Austausch der Kipphebel bei ROTAX 912 (Serie)

Replacement of rocker arms on ROTAX 912 (series)

Inspection and replacement of rocker arms

All engines of **Type 912 A (series) from S/N 4,005.196 to S/N 4,380.789 and Type 912 F (series) from S/N 4,412.501 to 4,412.534.**

Bild / pict. 2

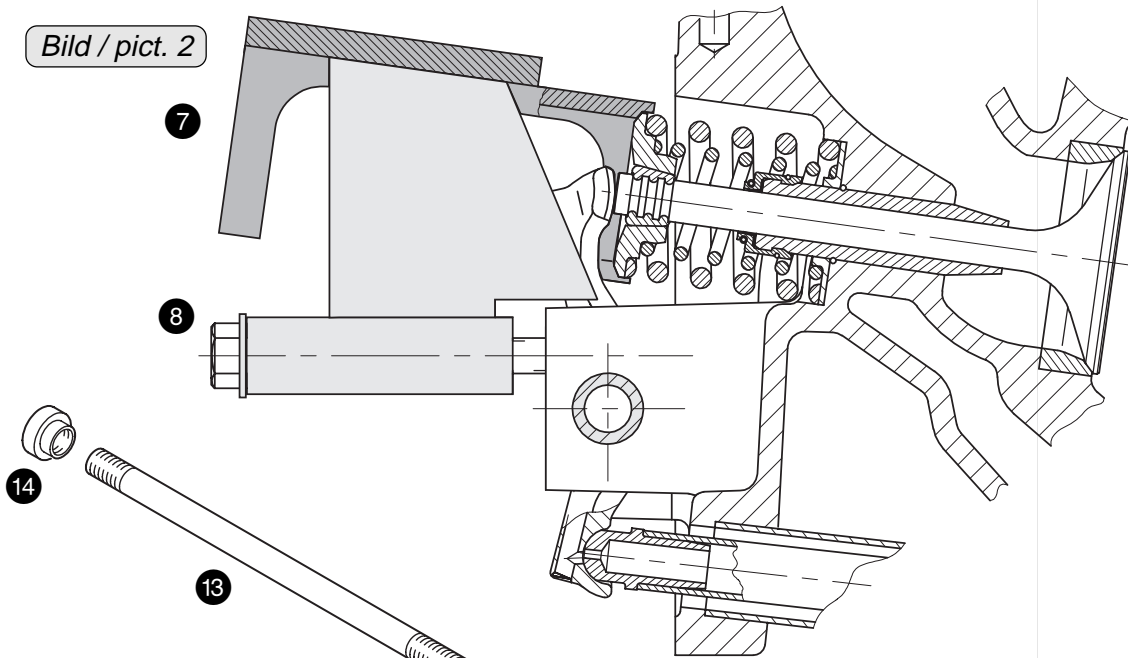
Turn crankshaft so that the respective piston is on ignition top dead centre. Remove the external cap nut ⑥. Screw valve spring spanner ass'y ⑦, part no. 877 385, with hex. screw ⑧ M6x70 onto the cylinder head and depress both valves by 3 turns, thus releasing both hydraulic valve tappets. Now the rocker arm shaft ⑨ can easily be removed. Withdraw both rocker arms ⑩ and ⑪.

If the rocker arm has traces of seizure, the rocker arm shaft can only be removed with the rocker arm extractor ⑫ part no. 877 770. For this purpose push the threaded bolt ⑬ with the short thread ahead through the hollow rocker arm shaft and screw on the special nut ⑭. Push rocker arm shaft as much as possible towards outside so that the extractor sleeve ⑮ can be centered on it. Fit the extractor sleeve ⑮ and screw on extractor nut ⑯ with washer ⑰. By turning the extractor nut, the rocker arm shaft can be pulled out.

Bild / pict. 1

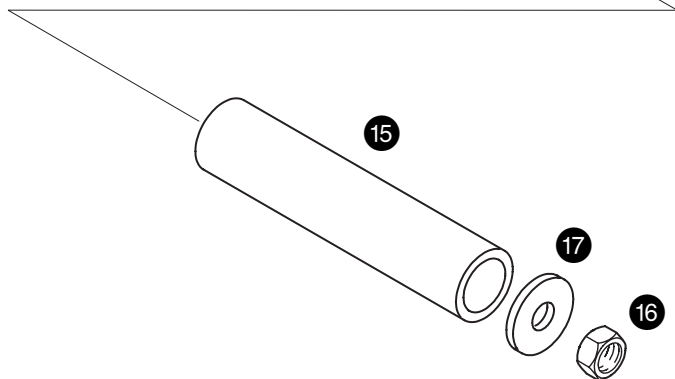
Remove Allen screw ① M6x25 with washer ② from valve cover ③ and remove valve cover with large and small O-ring ④ and ⑤.

Apply MOLYKOTE G-n 16 to the bore in the new rocker arm, to the push rod tip and valve contact surface. Place inlet rocker arm 10 and outlet rocker arm 11 into position, apply MOLYKOTE G-n 16 on both ends of rocker arm shaft 8 and insert it into its seat in cylinder head.

Lubricate all moving parts in the rocker arm space. Insert new O-ring 4 105x2,5 and O-ring 5 6,4x1,8 into the valve cover 3. Clean the sealing surfaces, fit valve cover and tighten the Allen screw 1 M6x30 with washer 2 to 10 Nm (90 in.lb.). Repeat the procedure on all 4 cylinders.
